SEWAGE DISPOSAL SYSTEM

MARYLAND STATE DEPARTMENT OF HEALTH

SUBDIVISION Dayton Meadows ROAD 13826 Dayton Meadows Ct LOT 10, Sec. 1, Area 1

PROPERTY OWNER Mathew Penniman

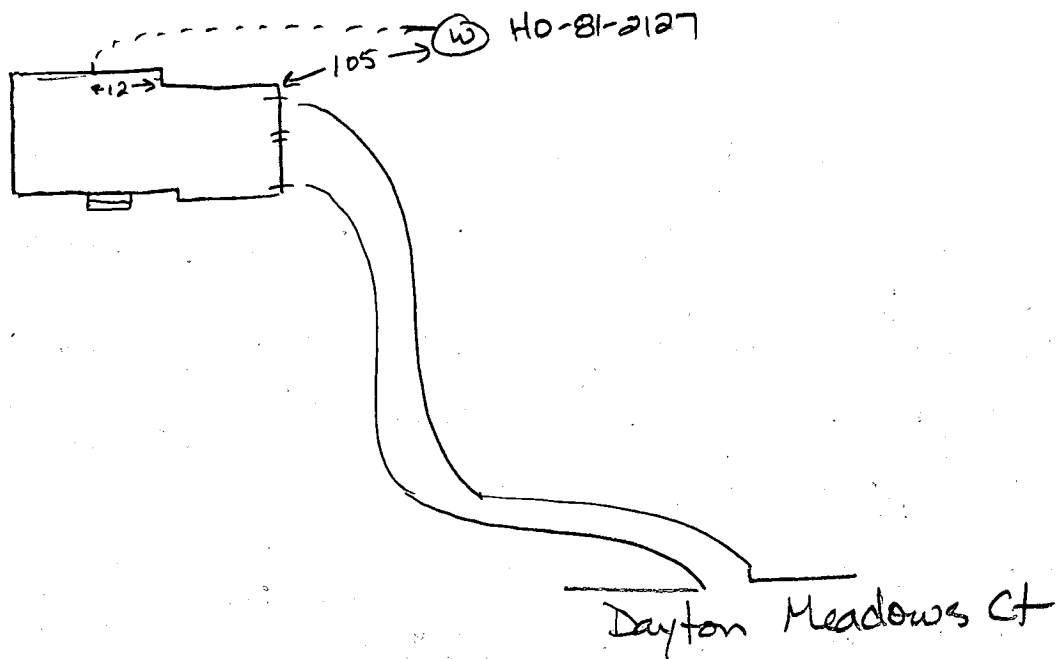
REMARKS 4-21-89 OK to stone trenches 1-3, leave trench #4 open at ends. Cement around tank and box. JEN

4-21-89 OK to cover trenches #1 & 2, Stone #3 leaving inlet open at ends of trenches #3 & 4. JEN

4-24-89 OK to stone trench #4. JEN

4-26-89 Must raise inlet to 4.0 ft in trench #4. OK to cover septic tank. JEN

4-27-89 Trench #4 inlet at 6.0 ft and level. OK to cover all work. JEN
